Re: St. Lucie Unit 2
Docket No. 50-389
RAI Reply for Refueling Outage SL2-18
Steam Generator Tube Inspection Report

Attachment

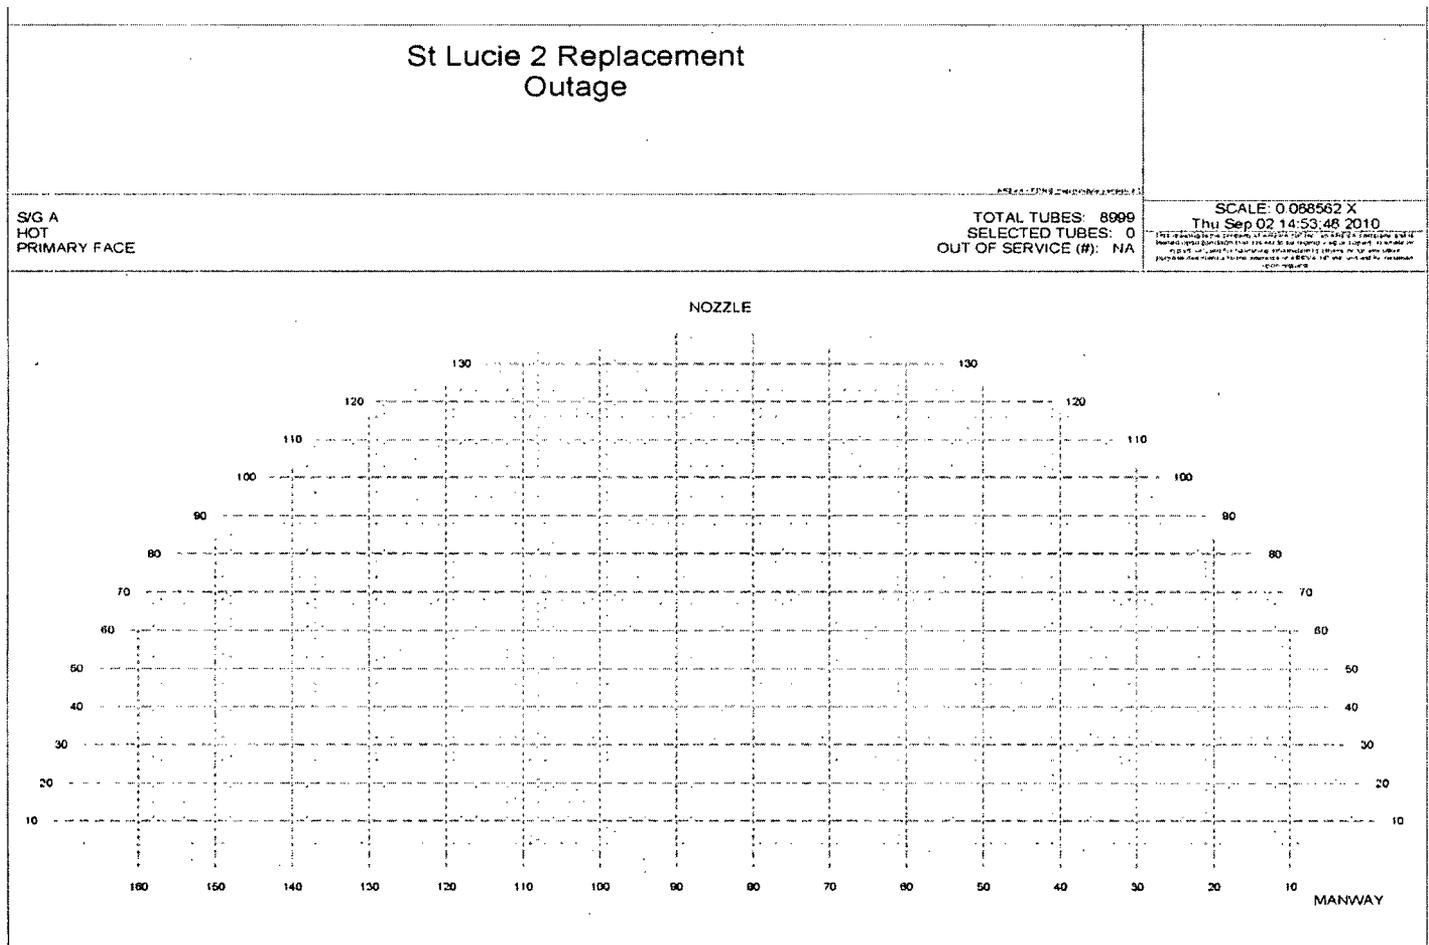
a. A tubesheet map depicting the row and column numbers,

Response: The tubesheet map below is generated from Areva software using SG configuration information. Rows run parallel to the divider plate and columns run perpendicular to the divider plate.
